NUREG-2246

FUEL QUALIFICATION FOR ADVANCED REACTORS

Table B-1 Public Comment Submittals on Draft NUREG-2246

1
2 **Figure 3-1 Decomposition of the Main Goal**
3

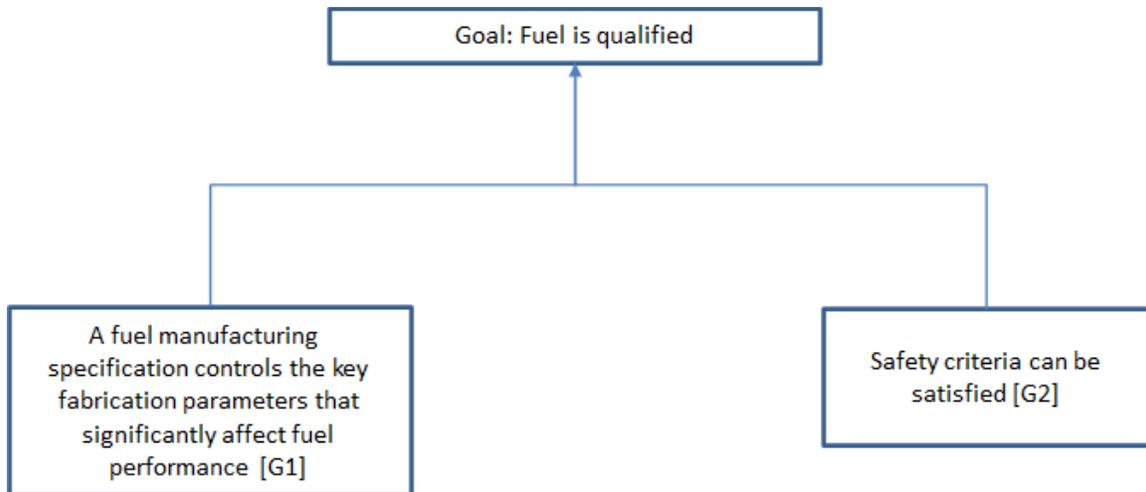
The main goal decomposition does not seem correct (Fig. 3.1). G1 and G2 not only goals for fuel qualifications. The manufacturing process and safety criteria vs. qualification? Truly not sure about it. Can you formalize, which “fabrication parameters significantly affect” what? At the same time, below “complete manufacturing specification is not expected as part of the licensing documentation”...

Regarding the listing in Table A-1, "List of Goals in Fuel Qualification Assessment Framework," NRC staff paraphrased the complete description of some goals for brevity.

The NRC staff made no changes to NUREG-2246 in response to this comment.

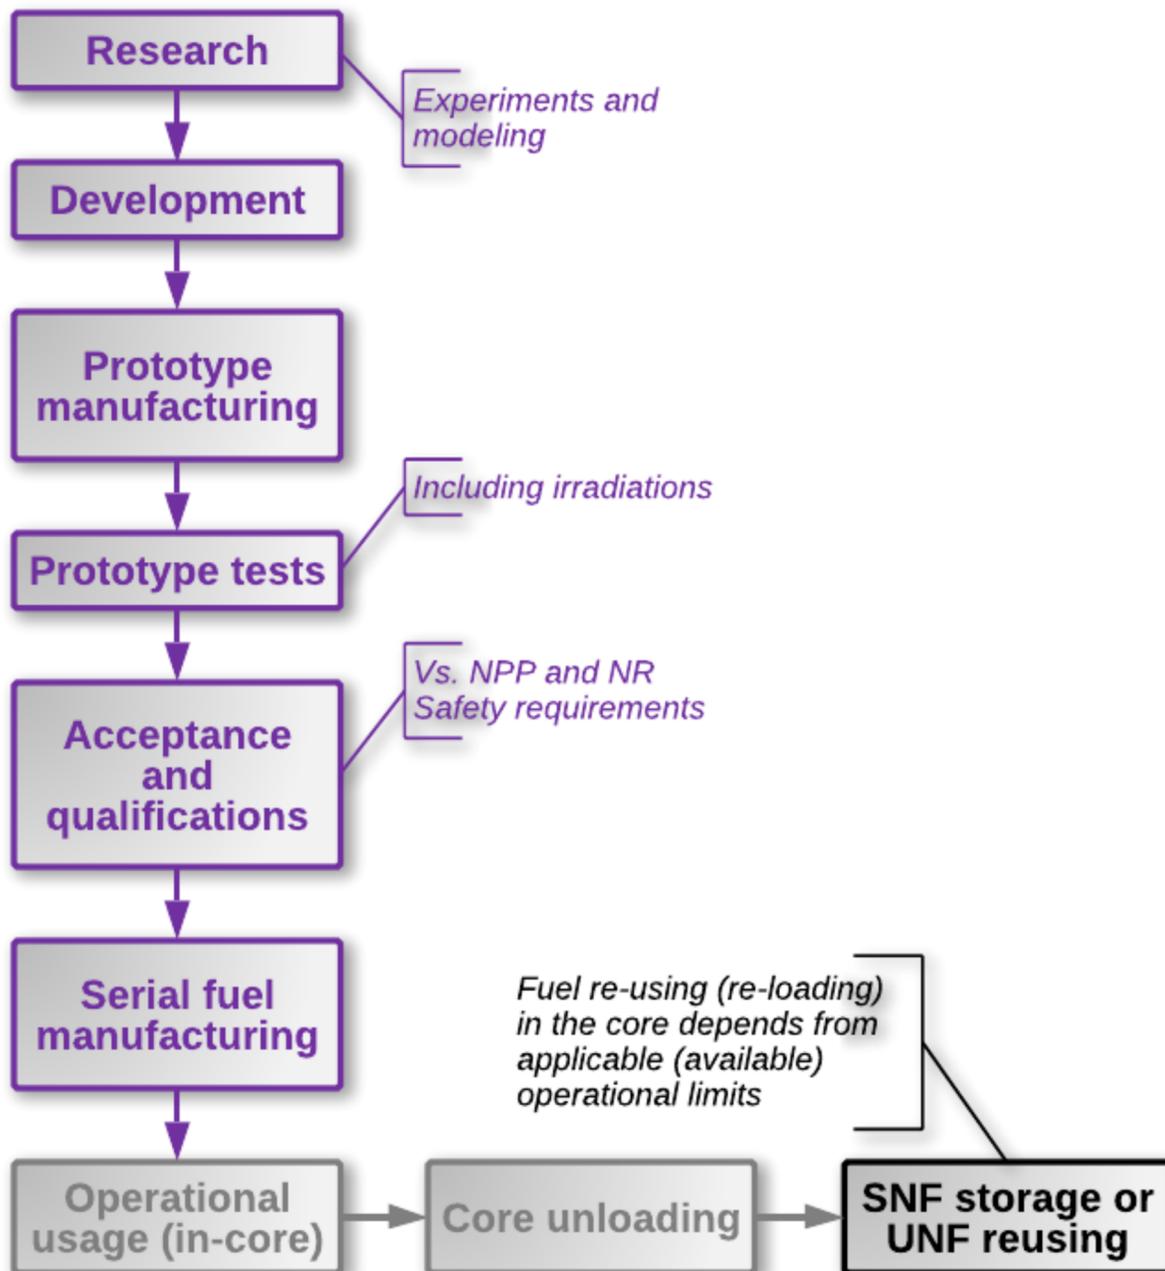
I have recreated the full diagram for subsections 3.1. and 3.2. See the figure for notes. Probably easy to understand author's ideas with this diagram. I couldn't understand why the authors use the term safety criteria instead of fuel acceptance criteria? Safety criteria for fuel connotations require a more precise definition, which will help the authors to clearly understand that this term, applied separately to fuel, does not seem correct.

Sections 3.3 and 3.4 do not contain anything new for fuel qualification process. Nothing from these sections would directly affect the modeling of fuel behavior and experiments with fuel. Any applicable and/or developed models, and any experiments in critical areas are evaluated according to approximately the same algorithms, techniques, procedures. And these procedures required justification separately, and definitely not in this document.

If subsections 3.3 and 3.4 should contain only recommendations specifically related only to the NR fuel qualification process and specified for this process exclusively, this will significantly reduce the disagreement between the developer and the licensee institute (NRC). Otherwise risk of endless discussions increasing.

That is, all descriptions, diagrams, and tables A-2 and A-3 do not make much sense and not related to fuel qualification process.

Comment No. 3-7

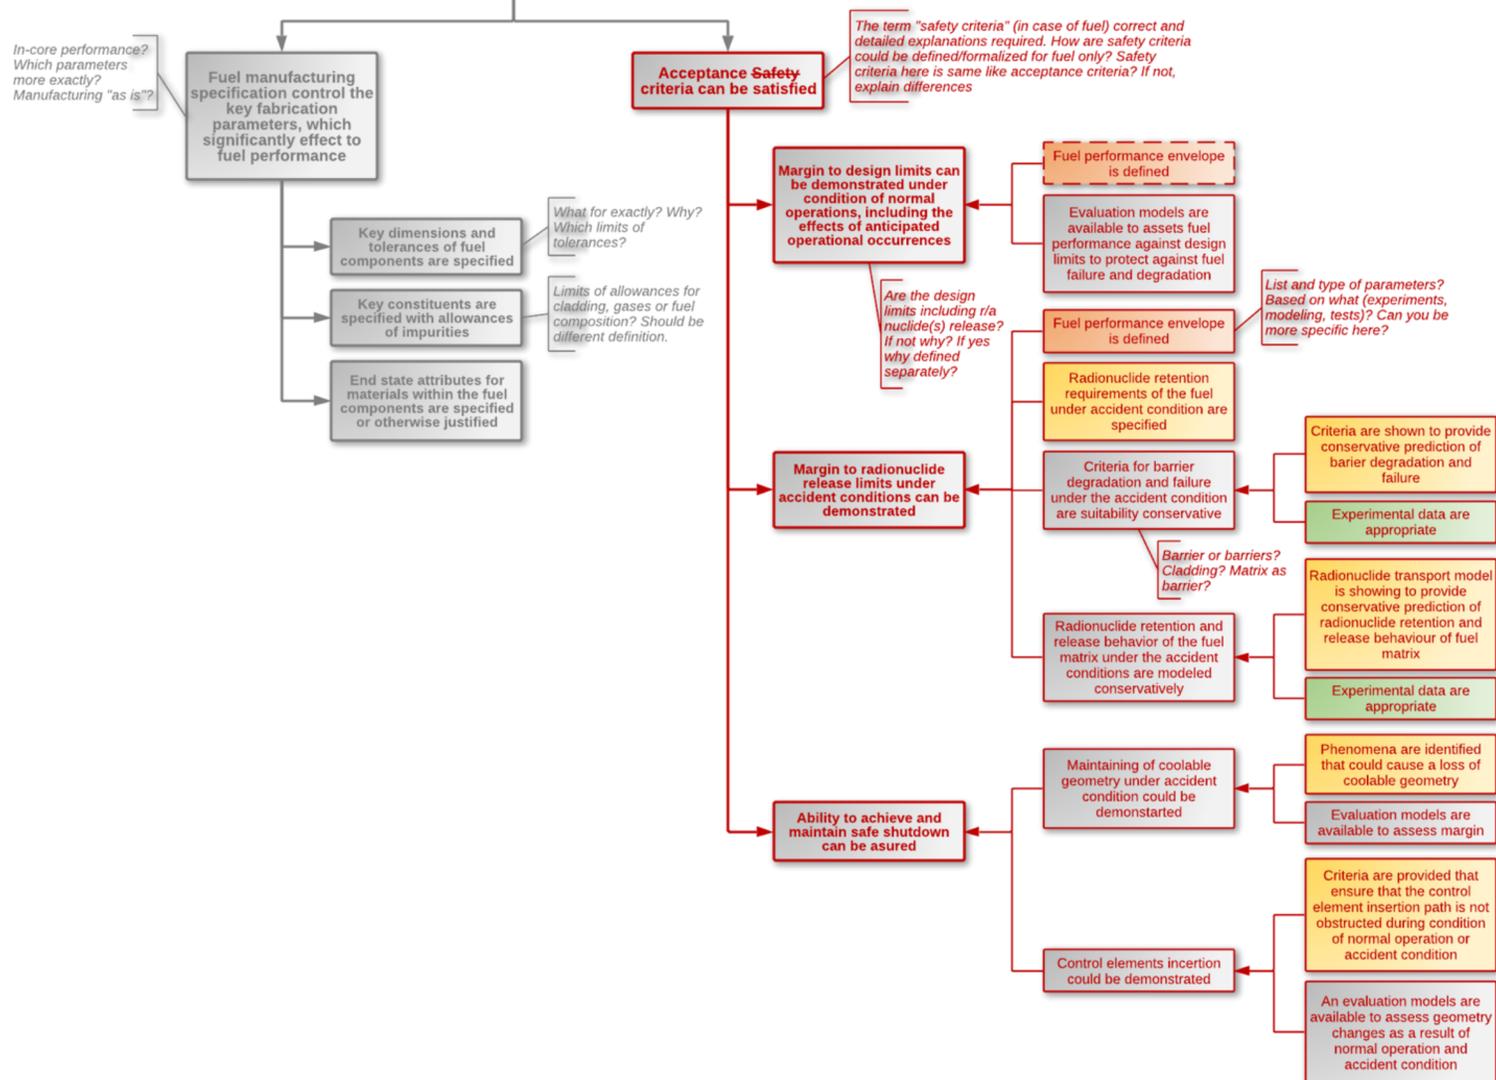
Additional remarks about your document would be presented on diagram (see below).
